UNITED STATES PATENT AND TRADEMARK OFFICE

APPLICATION NO.	FILING DATE	FIRST NAMED INVENTOR	ATTORNEY DOCKET NO.	CONFIRMATION NO.
10/780,914	02/17/2004	Milan Cerovic	101.00012	7564

DETAILED ACTION

Fig. 2

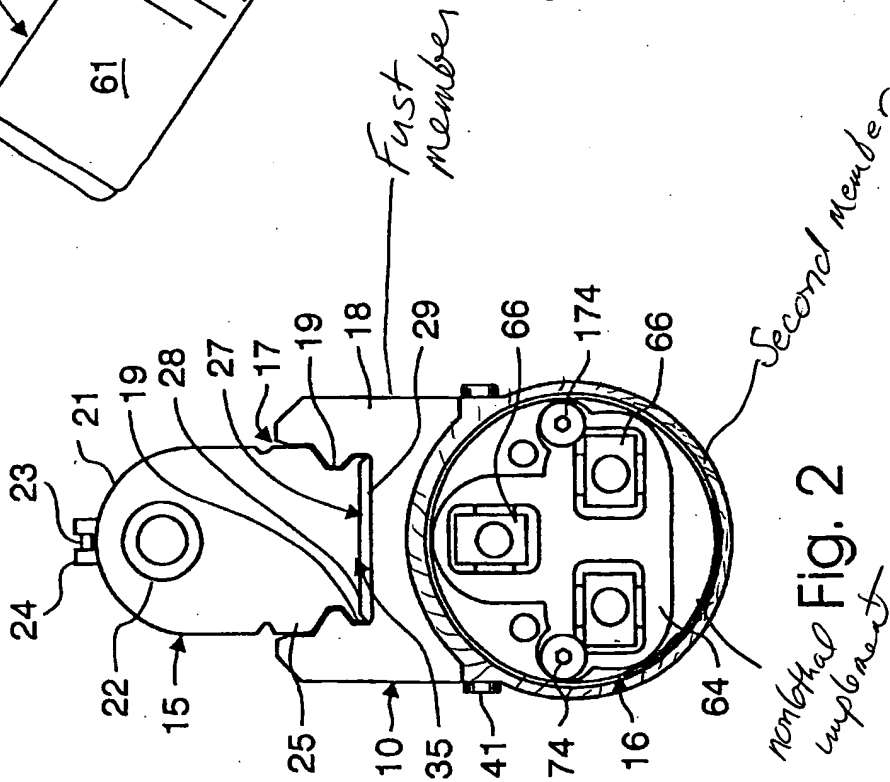
With regards to claims 18 and 19 Matthews et al. discloses a support that *has the ability to be* used to attach a non-lethal implement to a firearm that has a rail and a stop that is not part of the rail (it is noted that nearly any implement can be considered non-lethal), the support comprising: a first member, a second member coupled to the first member to form an assembly that *has the ability to hold an implement between the first member and the second member*, the assembly having a channel that *has the ability to receive the rail and a fastener that restricts motion of the assembly with respect to the stop thereby restricting sliding of the channel with respect to the rail, wherein the fastener is manually releasable without using a tool* (See examiner's notes on Figure 2).

Fast member

Second member

Nonbthal implement
